OMAouter measurement with SSPRQ

Laurent Alloin, Eric Maniloff, Amitkumar Mahadevan
Ciena

Draft Amendment to IEEE Std 802.3-2022
IEEE P802.3dj 200 Gb/s, 400 Gb/s, 800 Gb/s, and 1.6 Tb/s Ethernet Task Force

IEEE Draft P802.3dj/D3.0
16 February 2026

Figure 180-8—Example power levels P₀ and P₃ from PRBS13Q test pattern

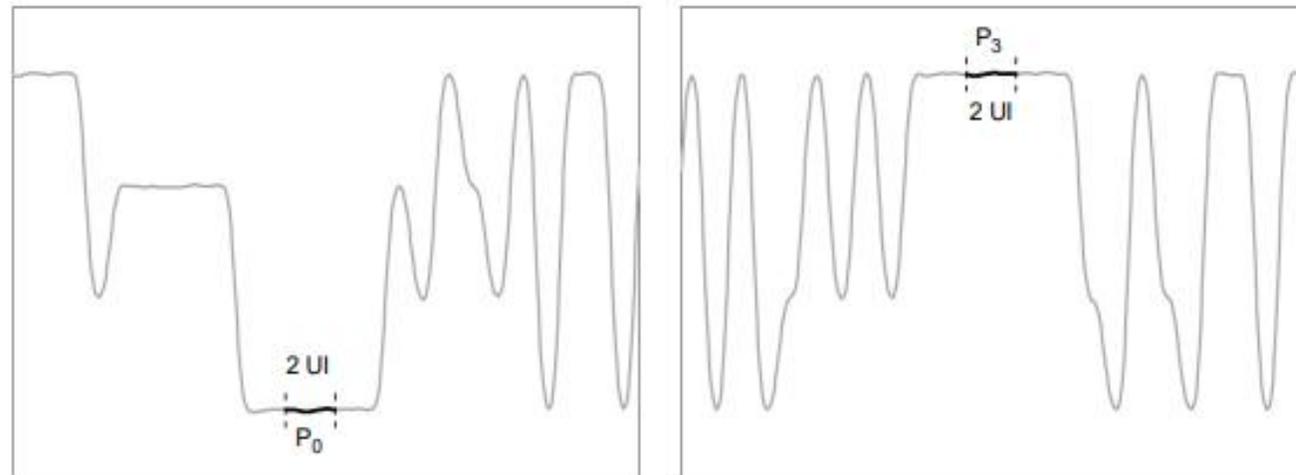
However, SC180.9.5 is tailored around the PRBS13Q signal structure !

OMA_{outer} is measured on a PRBS13Q or SSPRQ per Table 180-14 , looking for runs of 6 zeros and 7 ones

Proposed exception:

“When measured with SSPRQ, OMA_{outer} is measured as the difference between the average optical launch power level P_3 , measured over the central 2 UI of the first 7 UI of all runs of 7 threes or more, and the average optical launch power level P_0 , measured over the central 2 UI of the first 6 UI of all runs of 6 zeroes or more.”
